BUCKLAND and TAYLOR Ltd. CONSULTING ENGINEERS		BRITISH COLUMBIA DEPARTMENT OF HIGHWAYS BRIDGE DESIGN			
		LIONS' GATE BRIDGE MODIFICATIONS CONTRACT N ^o 1 - NORTH VIADUCT NORTH CABLE BENT TIE-BACK			
D		RECOMMENDED	SCALE: AS NOTED		
C		P. S. Buckland CONSULTING ENGINEER	DRAWN	RKCC APR 76	CHECKED
B		GENERAL ARRANGEMENT APPROVED			RCH MAY 76
A	REVISED TO AS BUILT	JGM	DRAWING No.		1481-76 A
REVISIONS		J. Galumson CHIEF HIGHWAY ENGINEER

LIONS' GATE BRIDGE MODIFICATIONS
CONTRACT N°1 - NORTH VIADUCT
NORTH CABLE BENT
TIE-BACK UPPER END DETAIL

**LIONS' GATE BRIDGE MODIFICATIONS
CONTRACT N°1 - NORTH VIADUCT
NORTH CABLE BENT
TIE-BACK ANCHORAGE AND JACKING BEAM.**

LIONS' GATE BRIDGE MODIFICATIONS
CONTRACT N^o 1 - NORTH VIADUCT
NORTH CABLE BENT
TIE-BACK ANCHORAGE DETAIL

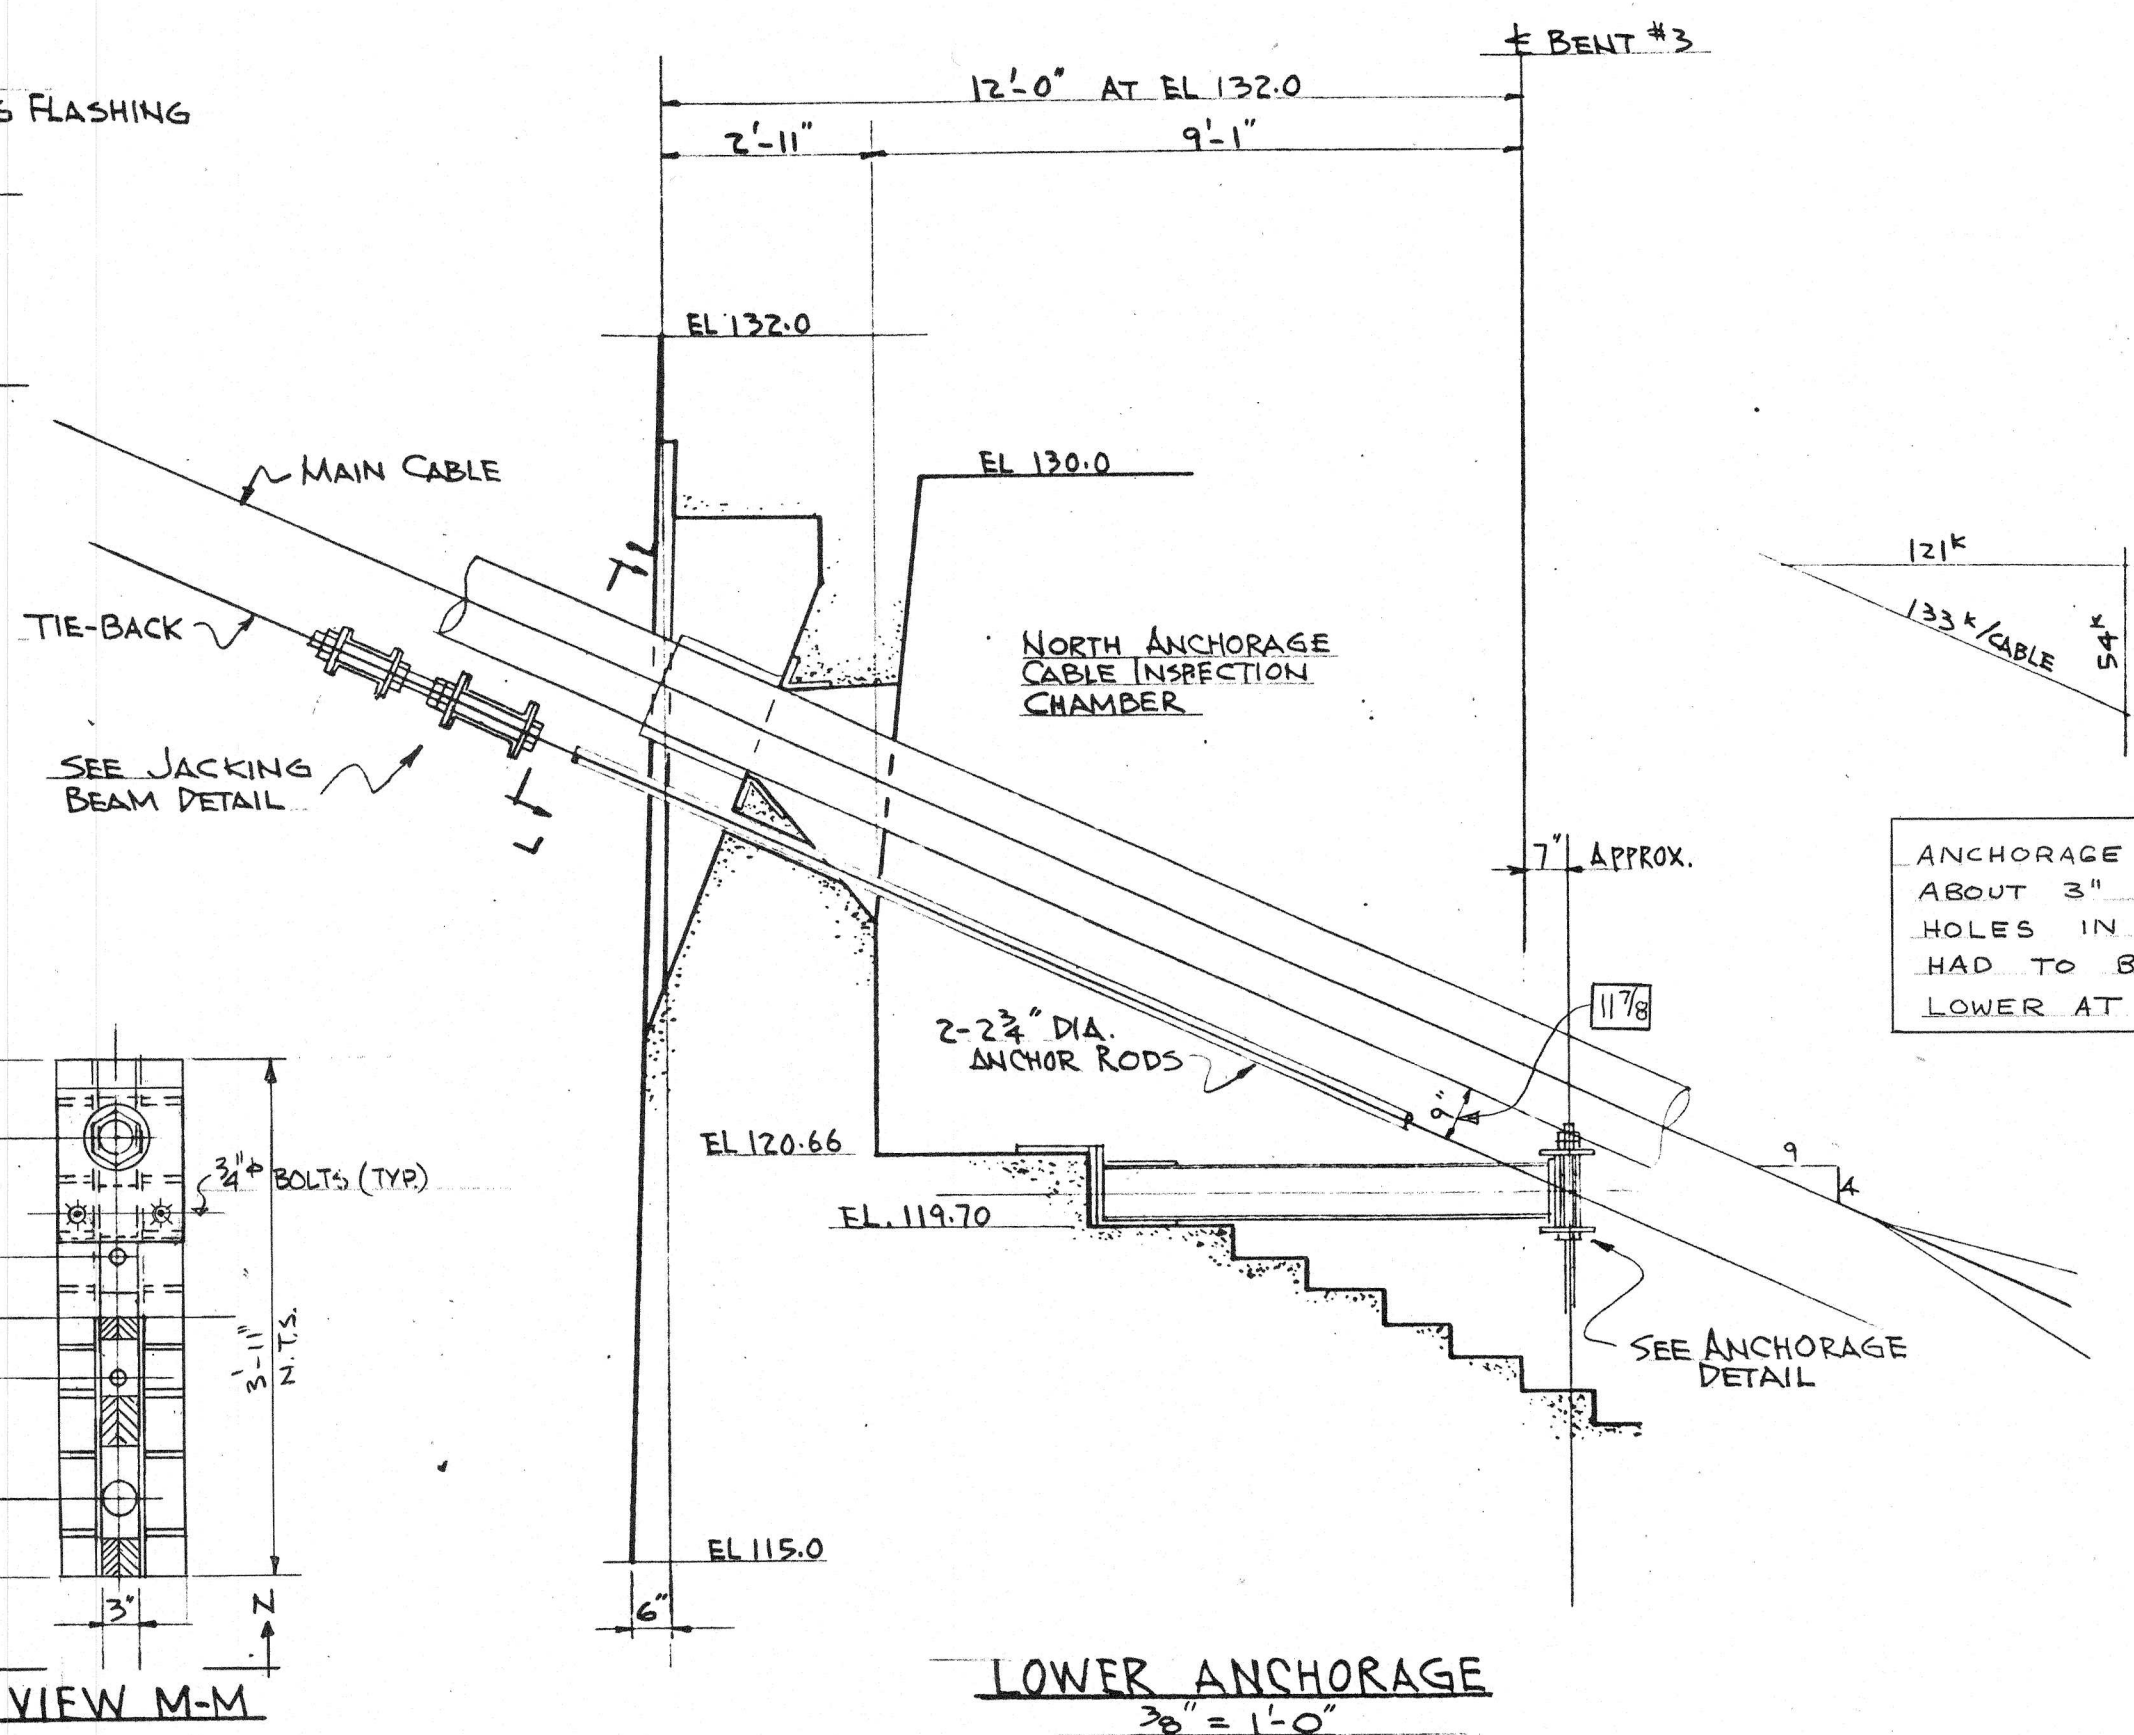
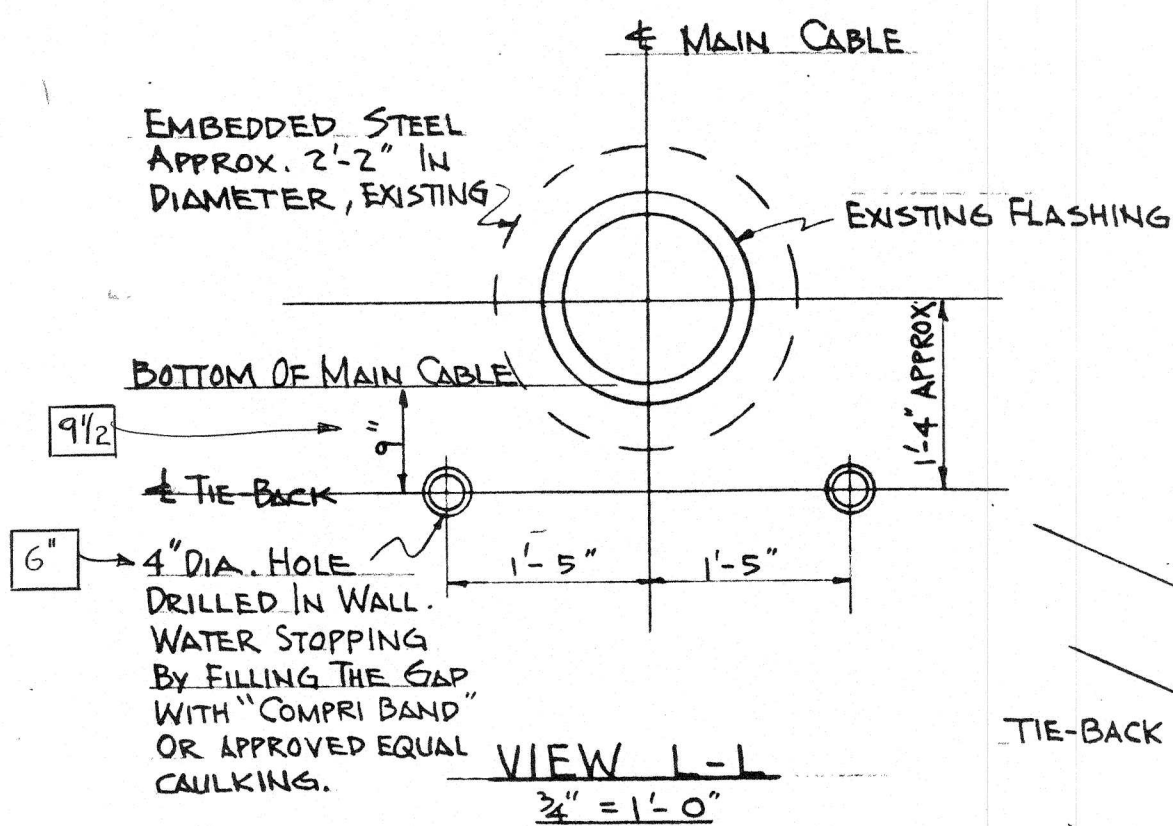
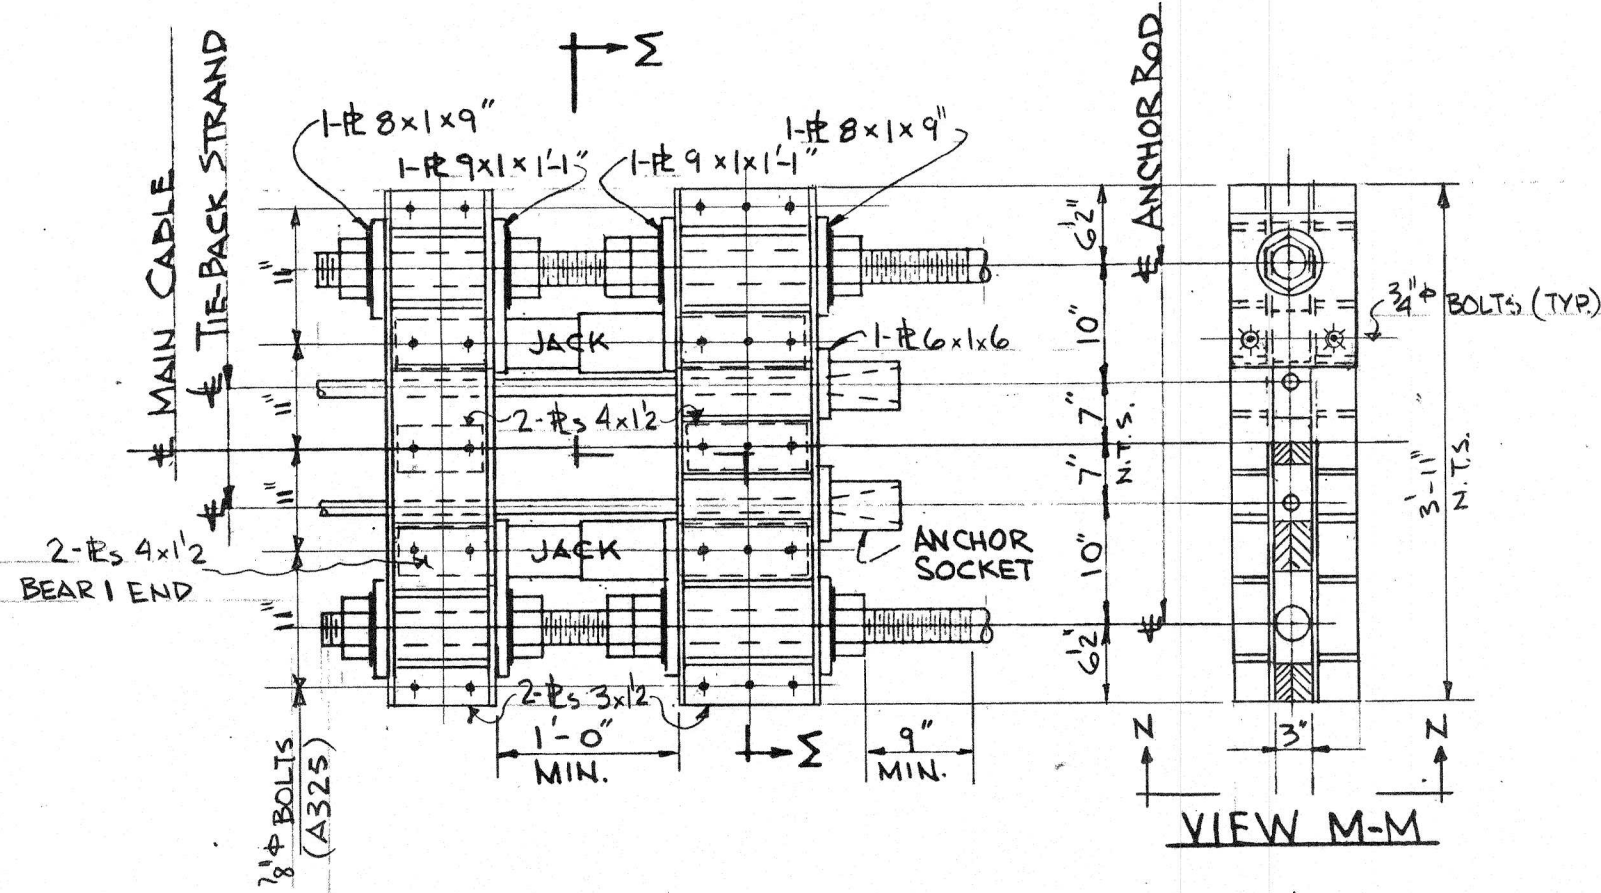
ANCHORAGE WAS ERECTED ABOUT 3" LOW SO THAT HOLES IN CONCRETE FACE HAD TO BE REDRILLED LOWER AT 6" DIAMETER

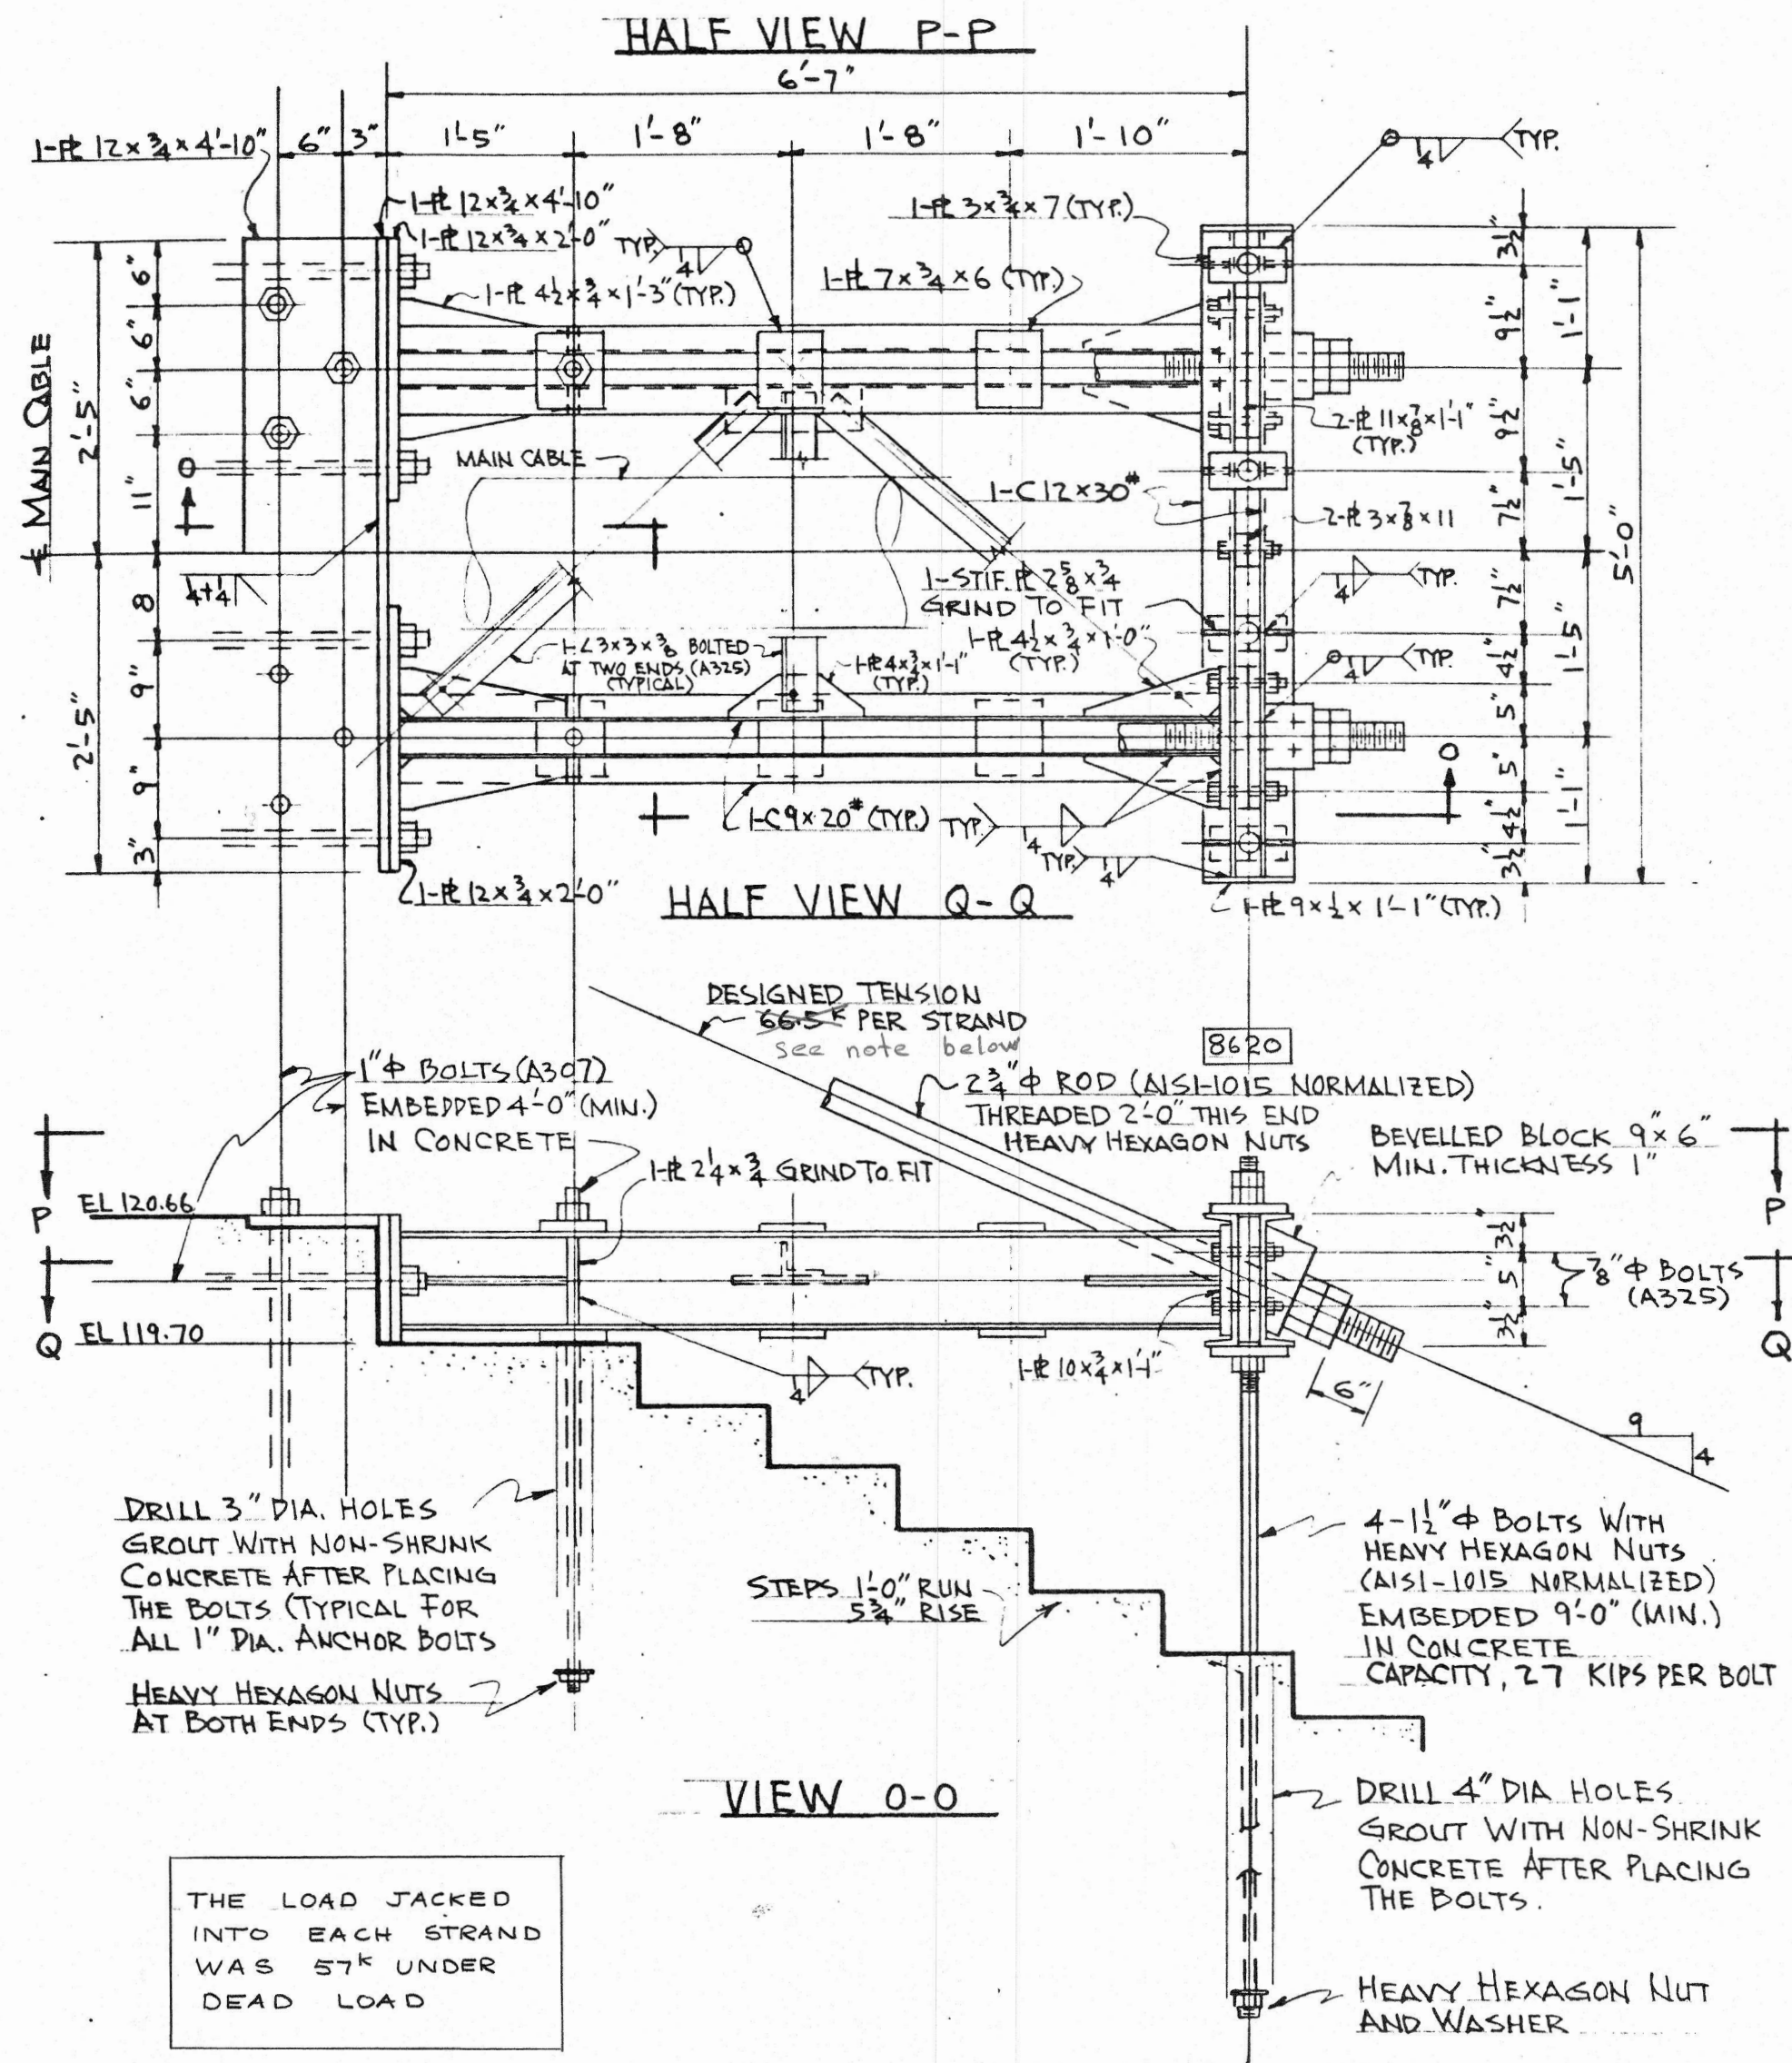
THE LOAD JACKED INTO EACH STRAND WAS 57k UNDER DEAD LOAD

8. SAMPLING AND TESTING OF EACH STRAND ARE REQUIRED, AND SHALL CONFORM TO THE SAME ASTM A586-68 SPECIFICATIONS.
9. THE OPEN STRAND SOCKETS SHALL BE HIGH-STRENGTH STEEL CASTING, GRADE 80-50, NORMALIZED, STRESS RELIEVED, AND CONFORMING TO ASTM A148 STANDARD SPECIFICATIONS FOR HIGH-STRENGTH CASTINGS FOR STRUCTURAL PURPOSES. THE FINISHED CASTINGS SHALL ALSO BE TESTED BY RADIOGRAPHIC INSPECTION. [NOT TESTED]

1x37
